# WALTER STREET PROJECT

1 – 27A WALTER STREET & 452-460 WILLOUGHBY  
ROAD, WILLOUGHBY

MULTI-UNIT RESIDENTIAL BUILDING

## 5 | ISSUE FOR FURTHER CONSIDERATION

### CENTRAL LOADING ZONE

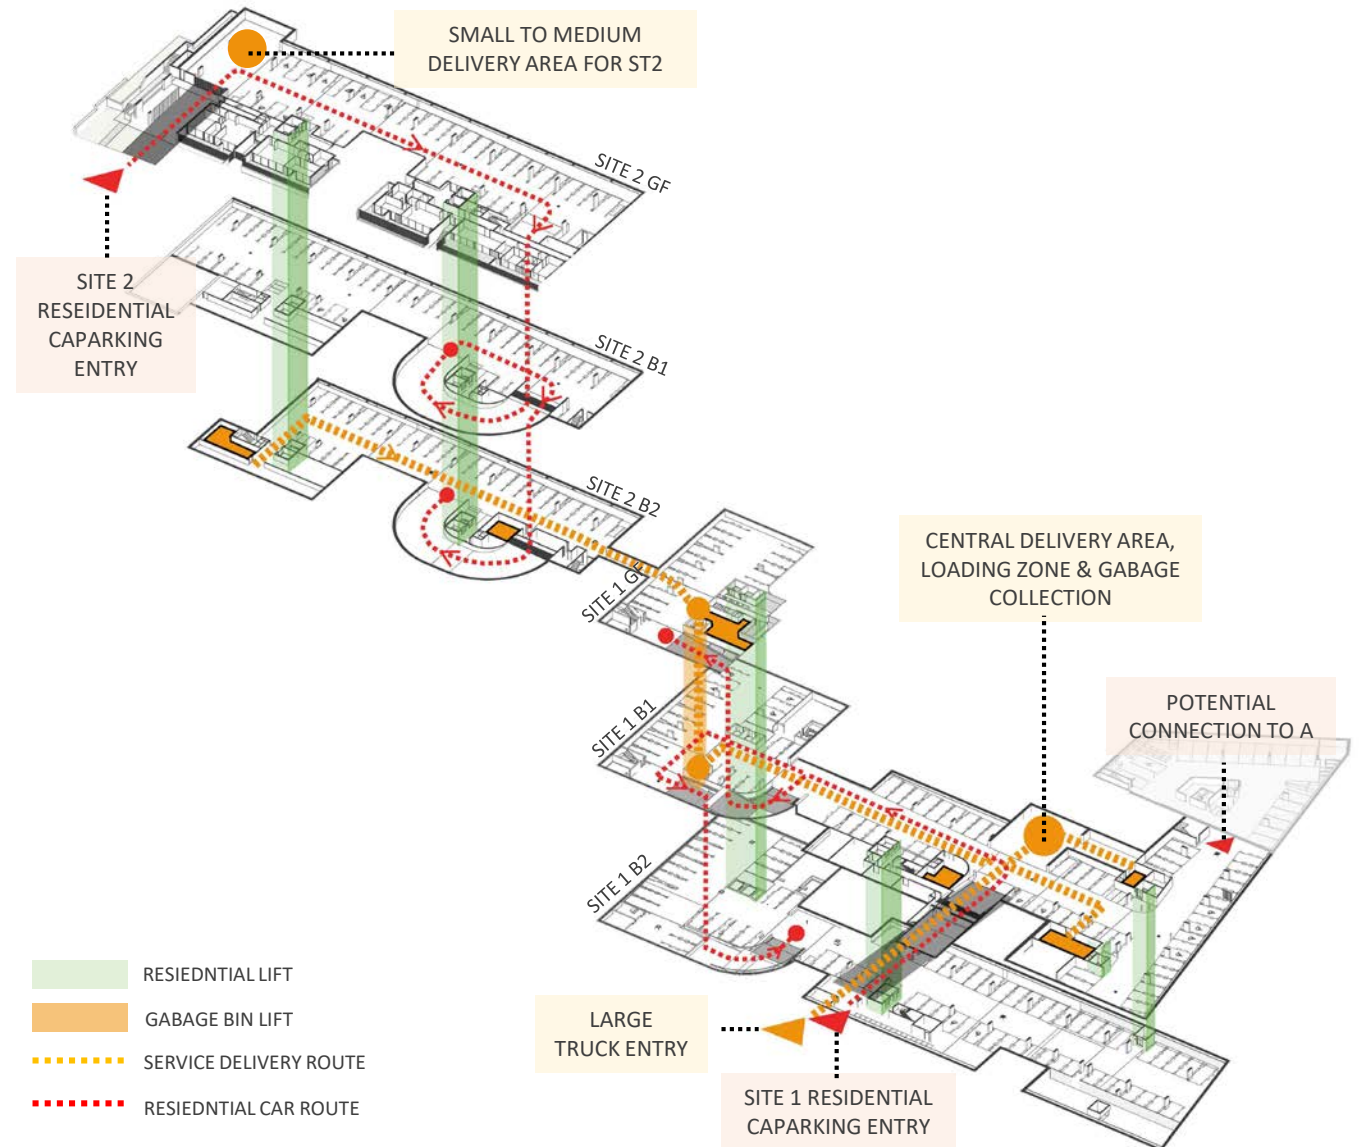
*'The number of apartments within the development should enable the project's basement access to be reduced to a single more centralized entry/exit point serving an interconnected basement.'*

- The site will operate best if there is **one centralized location** that can service all of site 1 including building A, providing car and truck access arrangement for deliveries and waste management through easement arrangement in compliance with the Objectives of the WLEP and site specific WDCP. The proposed access arrangement means that site A will not be isolated.

- As the project will be staged and due to the level differences between site 1 + site 2; a separate driveway has been provided to service each site for car and truck access for deliveries. The proposed arrangement meets with the objectives of Site specific DCP providing **2 separate Driveway access** points which will spread the traffic on Walter Street rather than intensifying it in one location.

- We have provided a **connection** from basement 2 of site 2 through to site 1 basement level under block D for **garbage transfer** from site 2 to Site 1 garbage pickup area.

- We believe that this arrangement creates unnecessary difficulties in garbage manageability as it has to be taken horizontally into site 1 and then down one level to basement 1 of site 1 and then taken to garbage pickup point for pick up.

- We believe that each site should be serviced separately.

## BUILDING CONNECTIONS

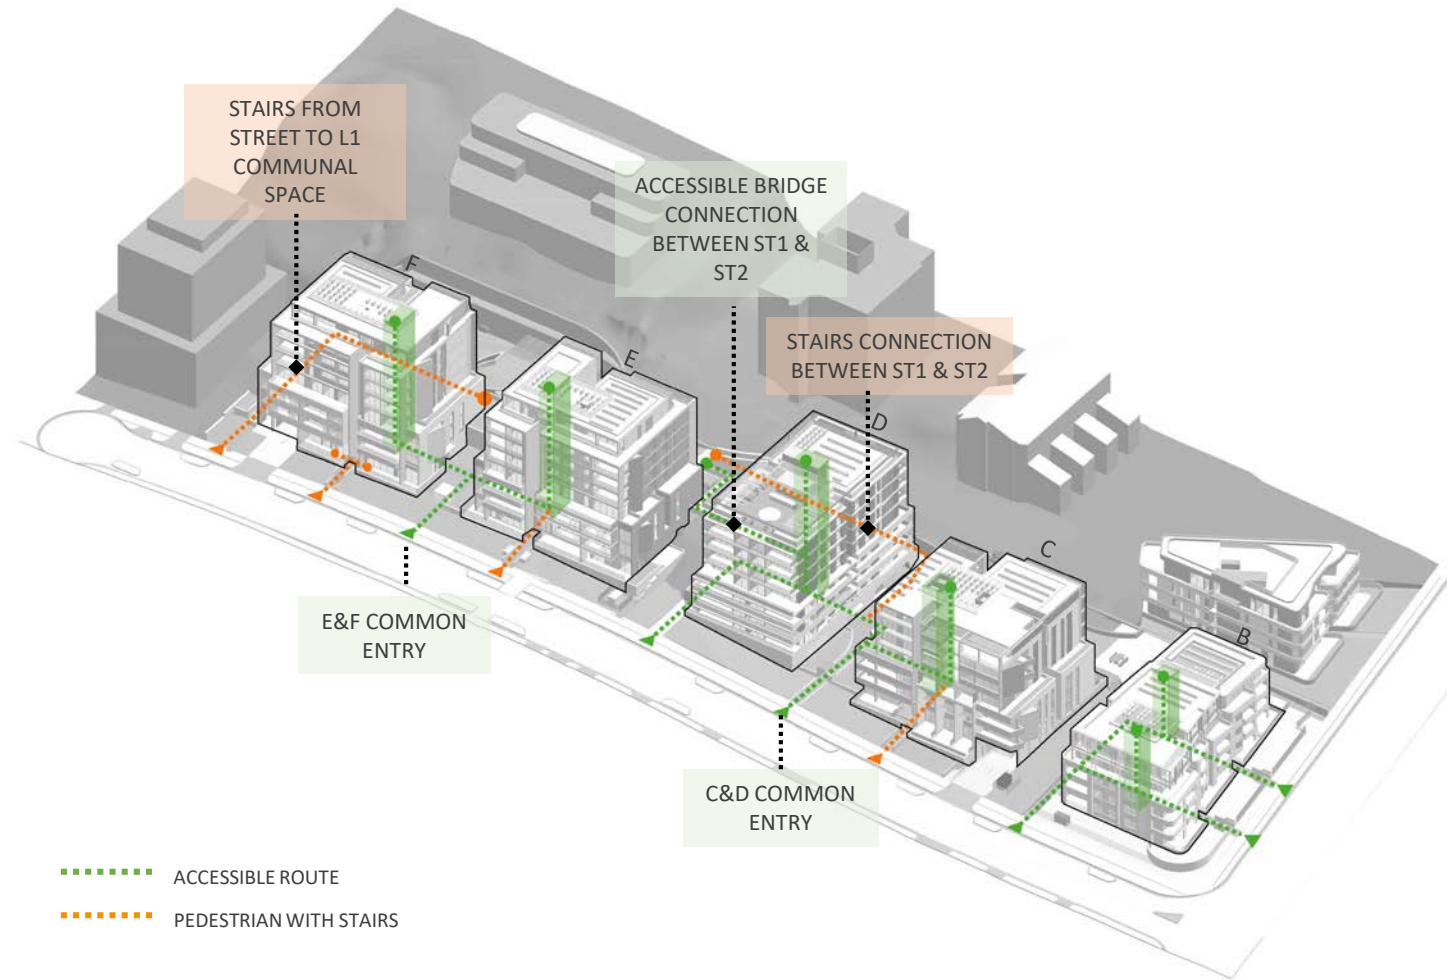
*'The proposed separations between the buildings are the least successful open spaces at ground level. They are dominated by vehicular access (Buildings B-C and E-F) and have no deep soil that might support plantings of large trees that would improve cross privacy and the tree canopy cover of the site, which should comply with State Govt and Council targets for bio-diversity and carbon capture.'*

- **In response** Driveways have been relocated under the buildings to create deep soil zones between buildings.
- **Building C+D, E+F are connected** on Ground level by creating landscaped garden entries and secondary entries to enhance social interaction and activate the public domain areas.

- **Individual access points** to ground level apartments from Walter Street and Willoughby Road frontages have been provided through the common access paths of travel rather than individual access points so they do not break up the landscape quality into smaller portions that would only benefit a few apartments rather designed to benefit the whole development and wider community and contribute to public domain areas around the site.

- **2 points of entry** have been provided for each building for enhanced permeability and public domain activation and social interaction at multiple points along each Street frontages.
